Addendum No. 1
September 23, 2010

Project: Dell Rapids New Elementary School
Dell Rapids, South Dakota

Architect: Architecture Incorporated

ADDENDUM 1 - CIVIL ITEMS - EXHIBIT 1

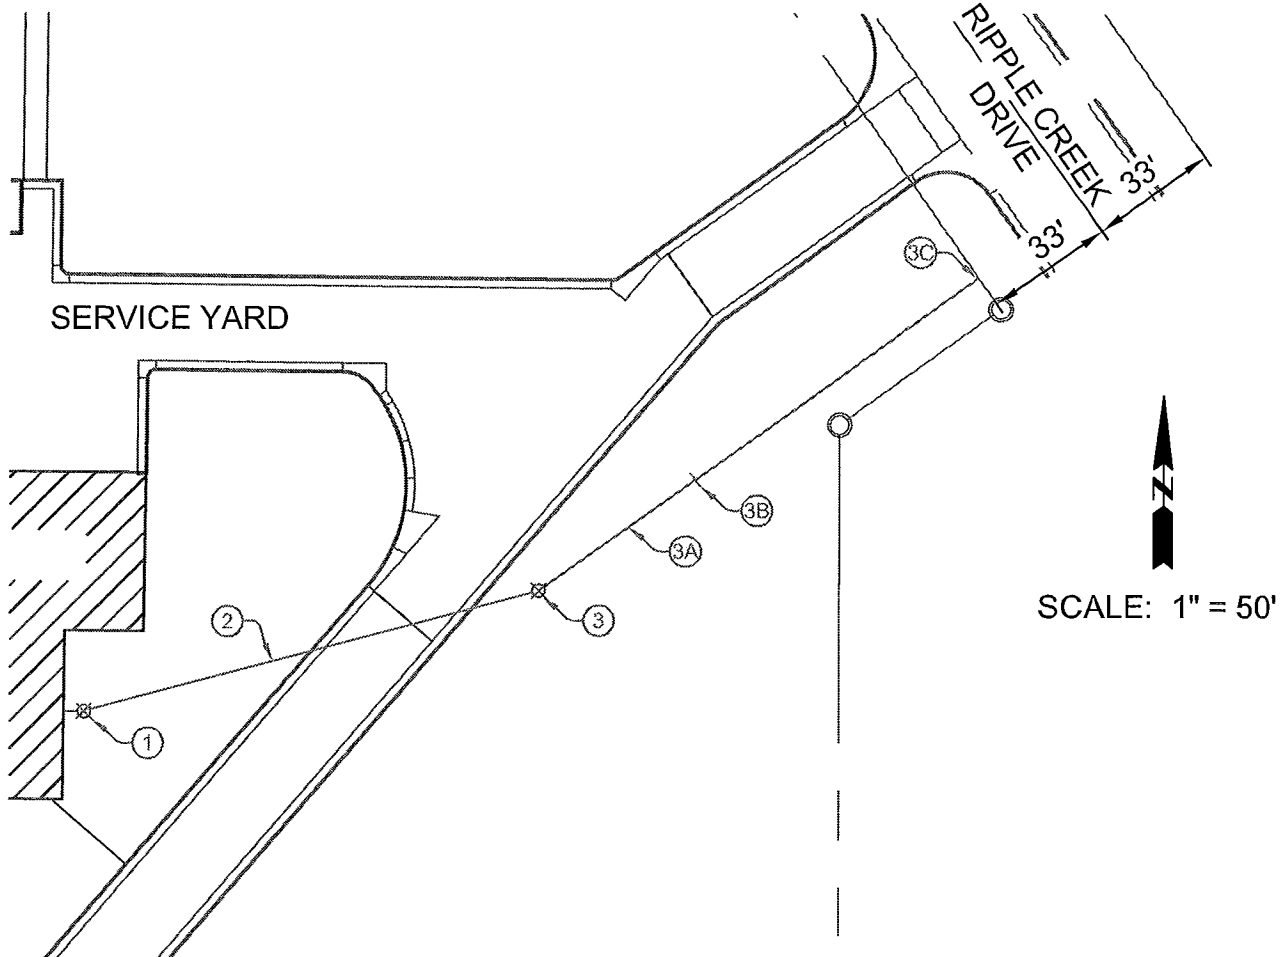
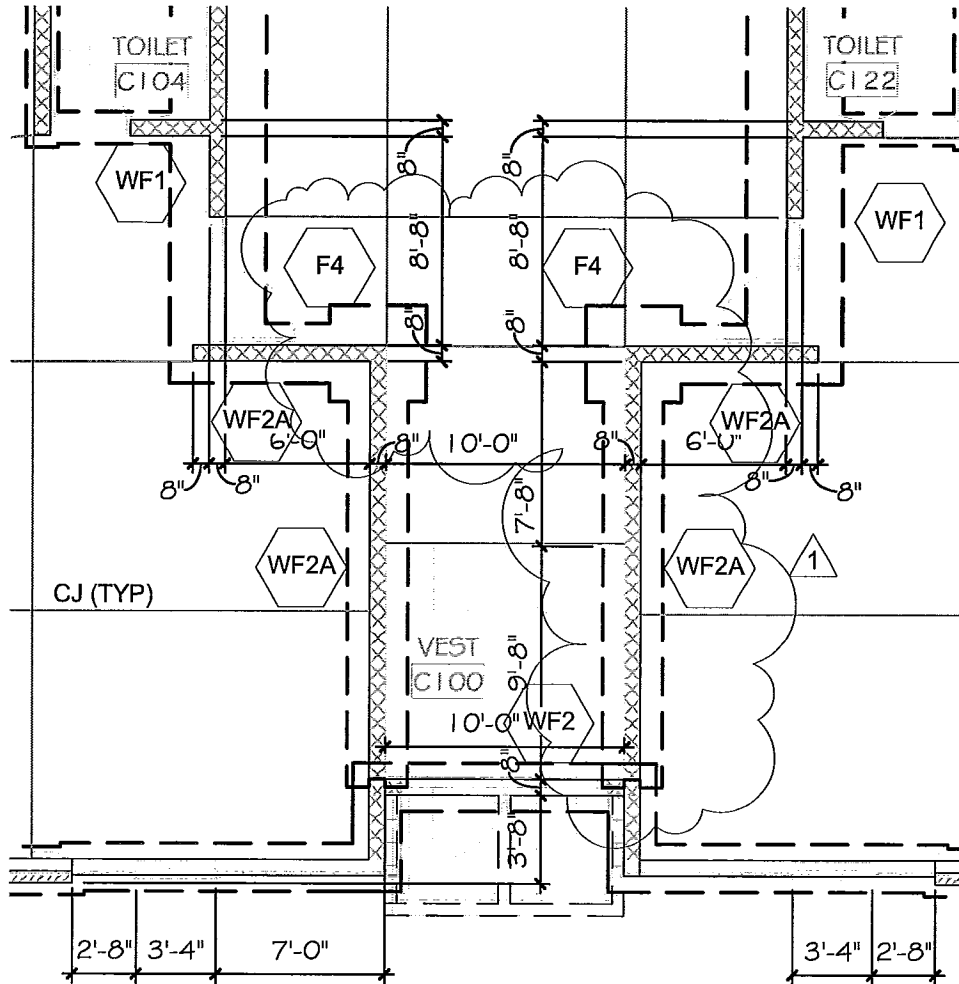
- 6) DRAWING SHEET 2.9:
 - a. See attached Sayre Associates Exhibit 1 for clarification of the sanitary sewer numbering.
- 7) DRAWING SHEET 3.4 - FOOTING AND FOUNDATION PLAN - AREA B & C

THE NUMBERING OF THE SANITARY SEWER HAS CHANGED AS FOLLOWS:

- ① CONNECT TO BUILDING
VERIFY LOCATION AND ELEVATION WITH
MECHANICAL PLANS
INSTALL 6" CLEANOUT WITHIN 5' OF
BUILDING
TOP = 1473.75
INV = 1466.50
- ② INSTALL 6" x 120' P.V.C. PIPE
(S = 1.00% MINIMUM)
- ③ INSTALL 6" P.V.C. CLEANOUT
TOP = 1566.40
- ③A INSTALL 6" x 140' P.V.C. PIPE
(S = 1.00% MINIMUM)
- ③B IN THE EVENT RIPPLE CREEK SANITARY
SEWER IS NOT ACCESSABLE AT SUCH TIME
AS THE SANITARY SEWER SERVICE IS
INSTALLED, THE CONTRACTOR SHALL
INSTALL ONLY SANITARY SEWER SERVICE
TO THIS LOCATION. AT SUCH TIME AS THE
RIPPLE CREEK SANITARY SEWER STUB OUT
IS AVAILABLE, THE CONTRACTOR SHALL
COMPLETE THE SERVICE INSTALLATION.
- ③C CONNECT TO SANITARY SEWER SERVICE
TO BE INSTALLED WITH RIPPLE CREEK
UTILITY PLAN. VERIFY INVERT PRIOR TO
INSTALLING SANITARY SEWER SERVICE.
CONNECT TO BELL END OF PIPE.

1
PARTIAL FOOTING AND FOUNDATION PLAN - AREA C
 SSD-1 1/8" = 1'-0"

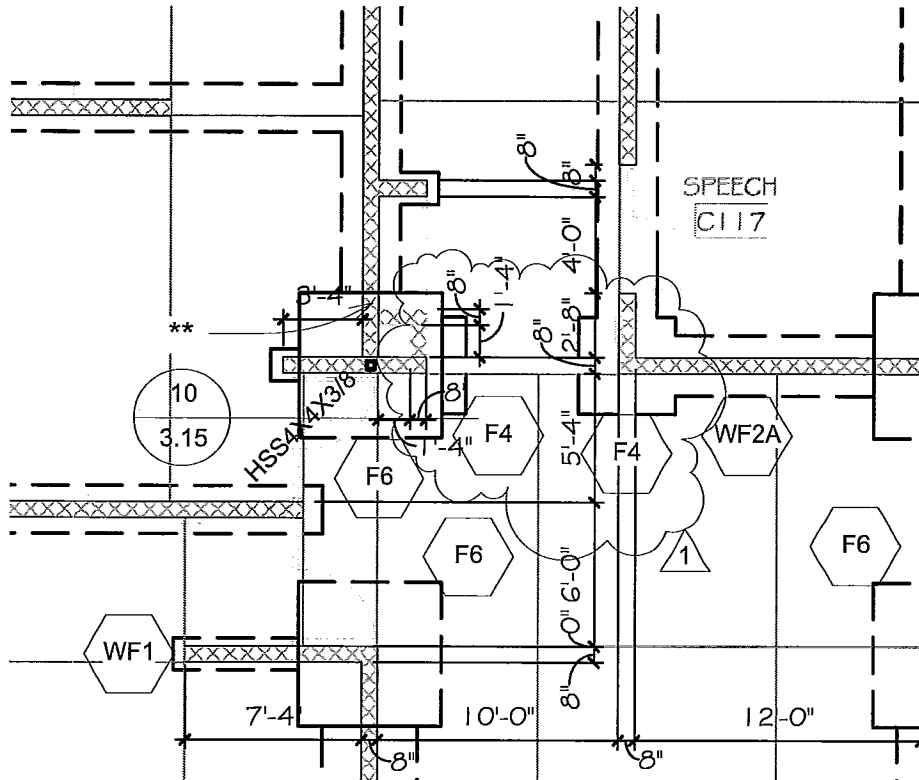
- a. Revise footings in AREA C as indicated in attached Supplemental Drawing SSD-1.
 - b. Revise footings in AREA C as indicated in attached Supplemental Drawing SSD-2.

SD-1 FLOOR PLAN - AREA D
 SD-1 SCALE: 1/8" = 1'-0"

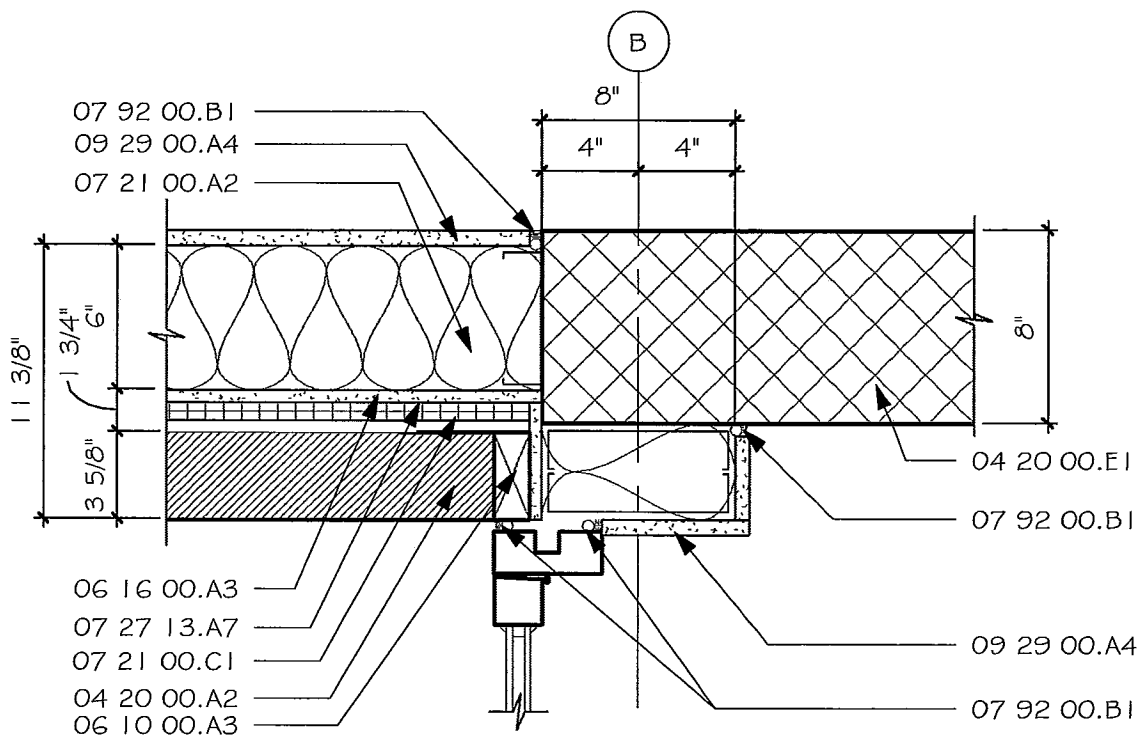
- 8) DRAWING SHEET 4.2:
 - a. See attached Supplemental Drawing SD-2 for modifications to Detail 5.
- 9) DRAWING SHEET 4.4:
 - a. See attached Supplemental Drawing SD-1 for dimension modifications at the south wall of Room D100.

DETAIL 7/4.10

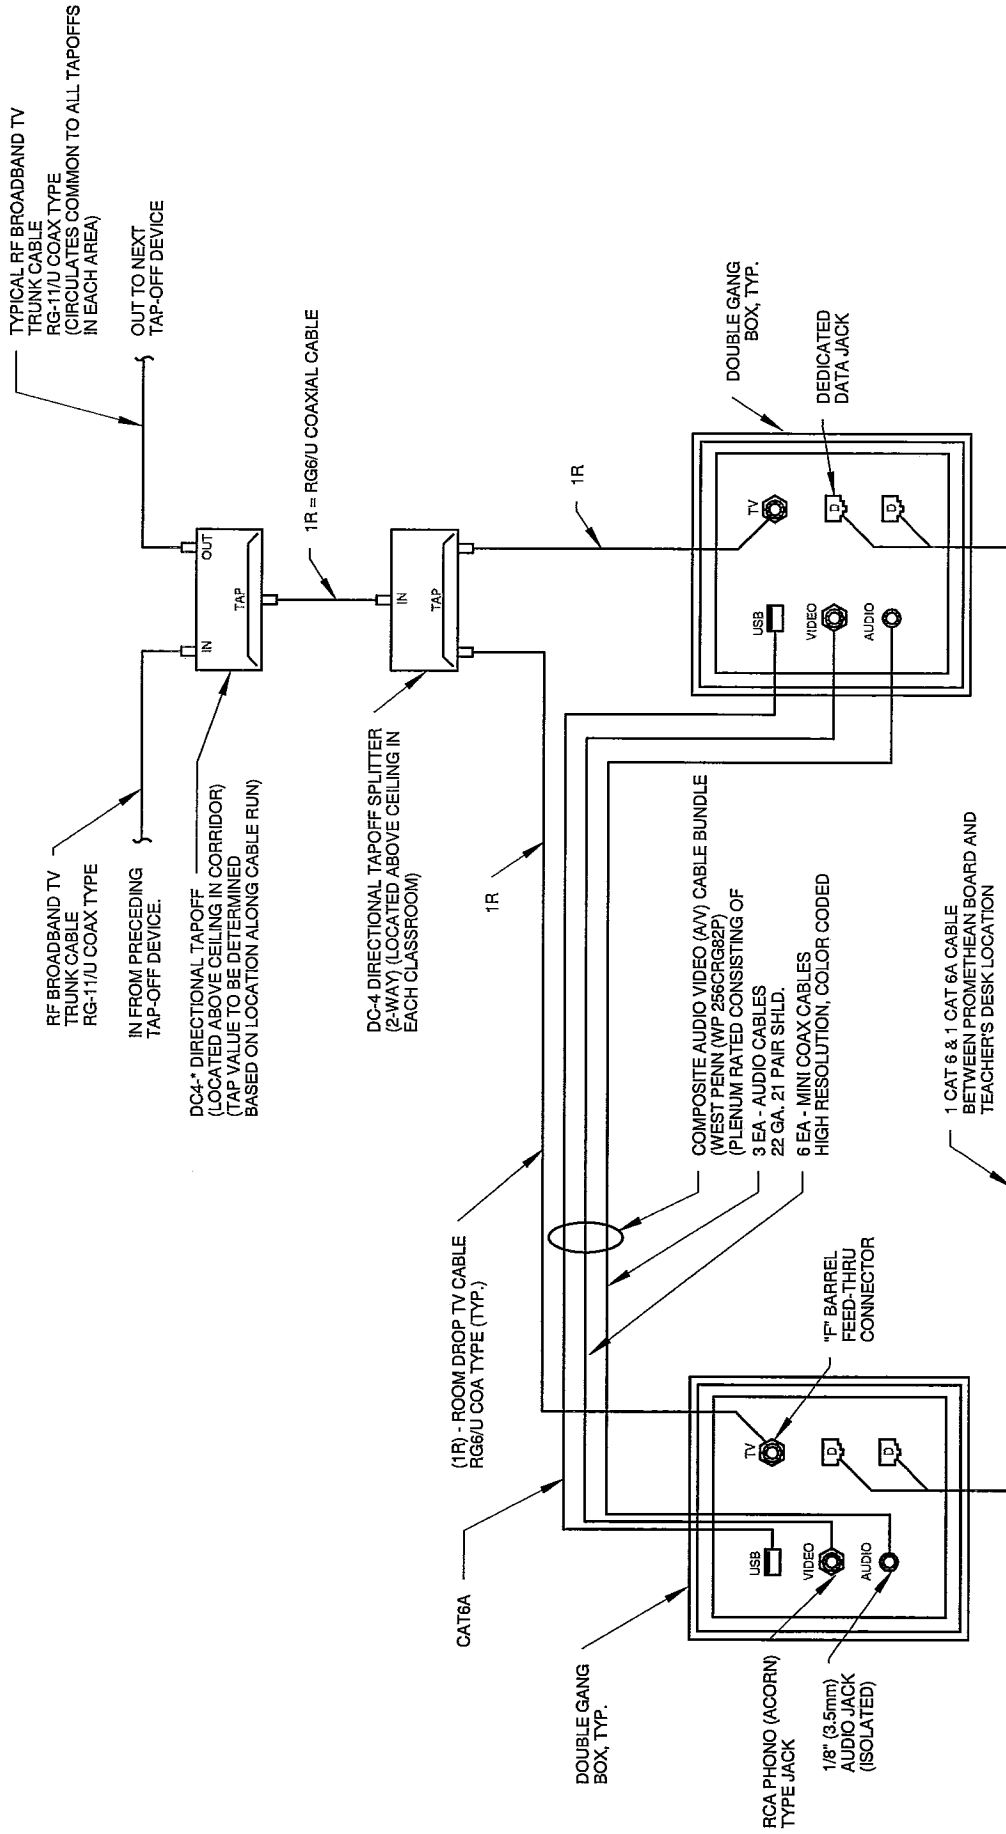
- 12) DRAWING SHEET 4.10:
 - a. See attached Supplemental Drawing SD-3 for modifications to Detail 7.
- 13) DRAWING SHEET 4.17:
 - a. Room A123 – provide motorized room darkening shades at clerestory windows in this room.
